Spruce Creek Culvert

CS 1602 (Bridge 8292)

Comments on SMSQ Architects Preservation and Restoration Report of December 2001

Prep by Gemini Research 11/14/03

3. HISTORIC PLAN AND DETAIL

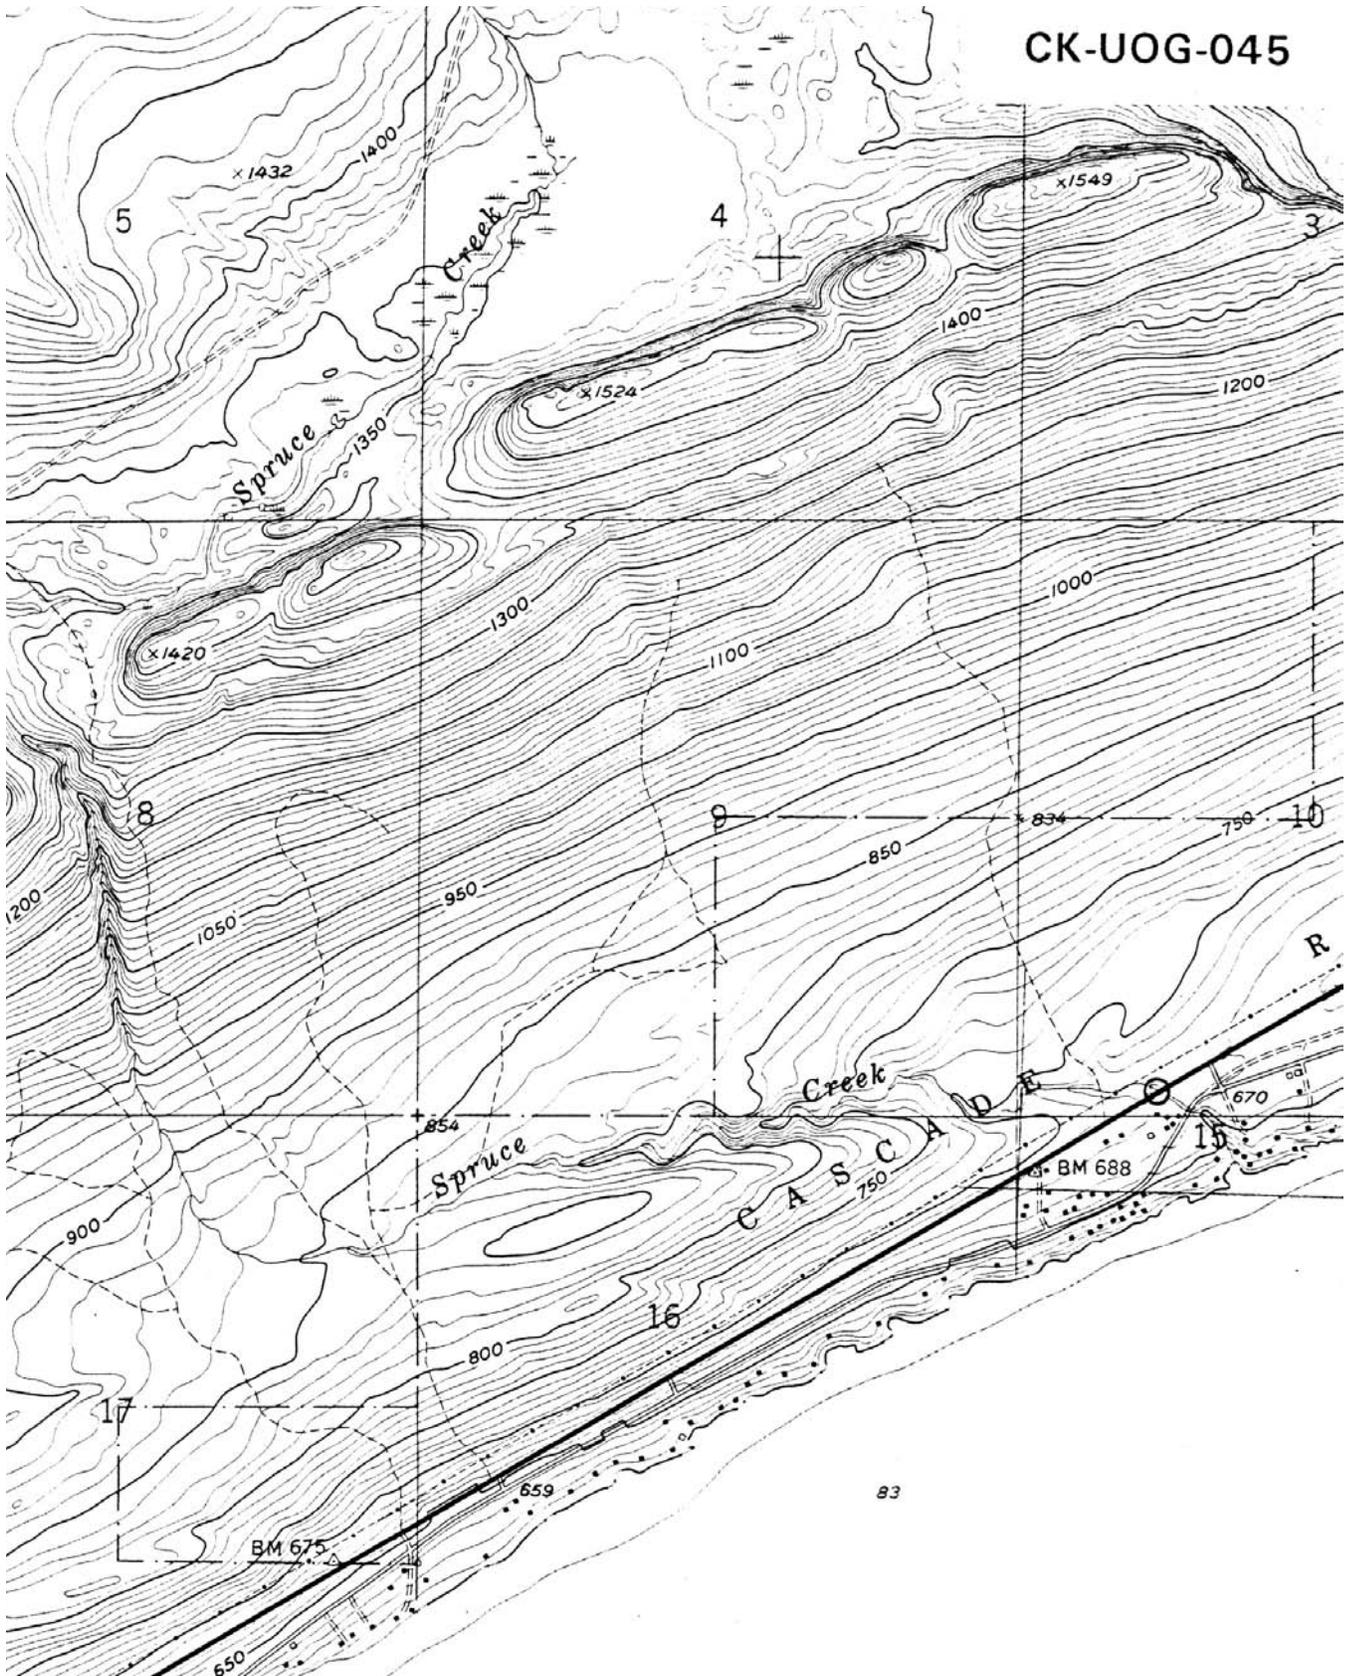
No original plans for the Spruce Creek Culvert had been located at the time of the original December 1998 Historic Roadside Development Inventory. Since then, we have found one early plan sheet, dated June 19, 1935.

(Note: The 1935 plan does not provide conclusive evidence as to the name the bridge designer. The only name that appears on the sheet is "Barber" in a box labeled "Checked by." Edward W. Barber was a landscape architect with the Minnesota Central Design Office of the National Park Service. He was a member of the team that designed the federal relief-built structures in Cascade River Wayside, as well as those at Gooseberry Falls State Park, Whitewater State Park, Flandrau State Park, and elsewhere.)

The 1935 plan sheet does not appear to be a final drawing. It shows a bridge railing different than the railing seen on the historical photo of the bridge in the Nichols photo album (vol. 5, pg. 22). The plan shows bridge railings that are about 130' long and have 20 stone piers linked by log rails. In the plan, the railings extend outward from the ends of the bridge to form highway guardrails. In the historical photo, however, each railing has only four stone piers for a total of 8 piers. It is likely that the other 12 stone piers shown in the drawing were never built. SMSQ notes in its report, however, that there are metal brackets on the ends of the railings that may once have attached to some kind of guardrail. SMSQ also notes that a 1973 Mn/DOT plan for guardrail changes contains the phrase "remove 20 stone pillars." (It is possible that the 1973 Mn/DOT directive to remove 20 stone pillars was made using the June 19, 1935, plan sheet, rather than final or as-built plans or field observations, and that Mn/DOT therefore thought

there were 20 piers to remove at the time the 1973 work plan was drawn.) As SMSQ indicates, further photo and plan research is needed before treatment is undertaken.
